Attachment A – List of Affected FSAR Sections

Attachment B - SGTR Figures

Attachment C - FSAR Addendum Markups

CALLAWAY PLANT
FIGURE 15A-1
RELEASE PATHWAYS

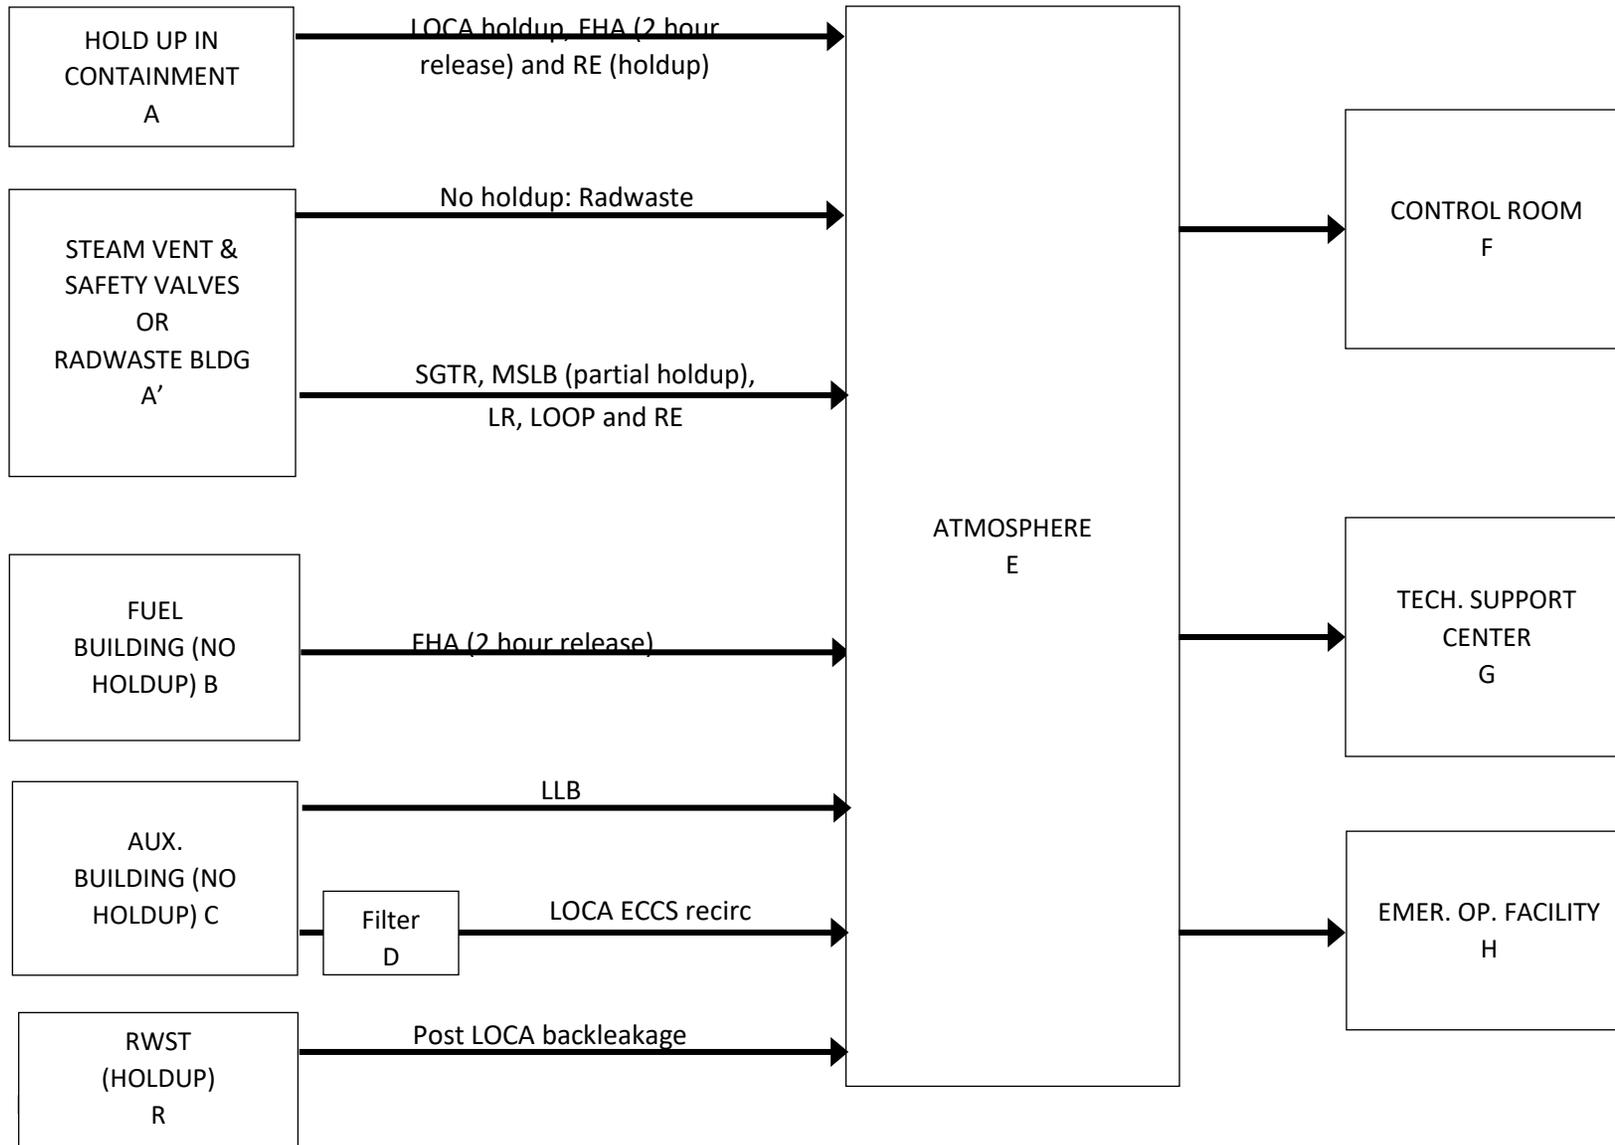
FHA: The release to the environment due to a fuel handling accident (FHA) in the fuel building is via vents. The release pathway is ~~B-C-D~~. Since the release is calculated without any credit for holdup in the fuel building, the total release will be the product of the initial activity and the filter nonremoval efficiency fraction (for noble gases, the nonremoval efficiency fraction is 1). The release of radioactivity to the environment due to FHA inside the containment is direct and unfiltered, via the ~~A-D~~ pathway without any credit for holdup (see Figure 15A-1). The release is calculated assuming the total gap inventory ~~is reduced by the pool decontamination~~ include a partition factor of 0.01 for non-noble gases, and 1 for noble gases.
